February 13, 2012
REL:11:053

**Subject: Application for Amendment to License No. SNM-1227 –
Authorization to Change License Application without NRC Pre-
approval and Change to Chapter 2.0, "Organization and
Administration"; AREVA NP Richland Facility (Docket 70-1257)**

Figure 2.1 Site Management Functional Organization

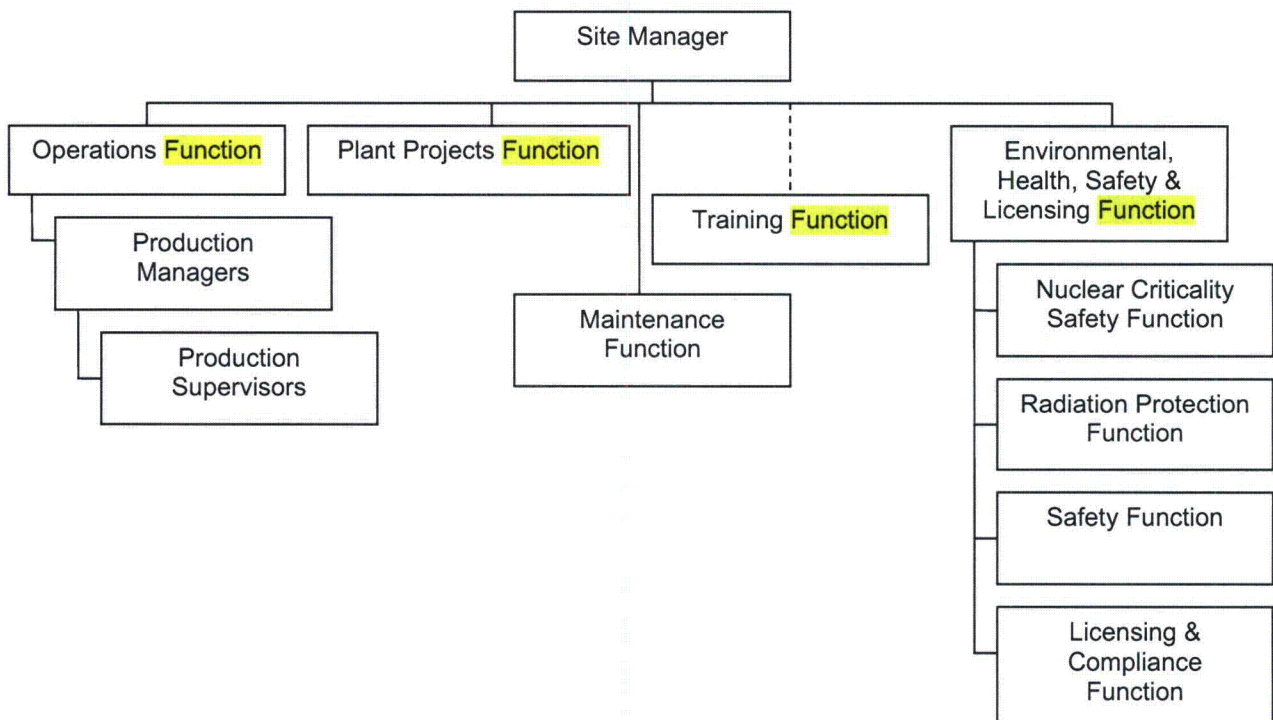
A revised Chapter 2.0 to License SNM-1227 reflecting this realignment is attached. The revised Figure 2.1 also has been modified to replace the designation "Manager" with the designation "Function" in a number of locations. This reflects the true purpose of Figure 2.1 in depicting functional relationships as opposed to management titles and furthermore is consistent with the narrative descriptions of the organization provided in Section 2.2.

Item	Paragraph	Description	Justification
1.	Figure 2.1	Removed maintenance function from operations function	Site organizational change
2.	Figure 2.1	Redesignated direct reports to Site Manager as functions	Consistent with functional organizational chart
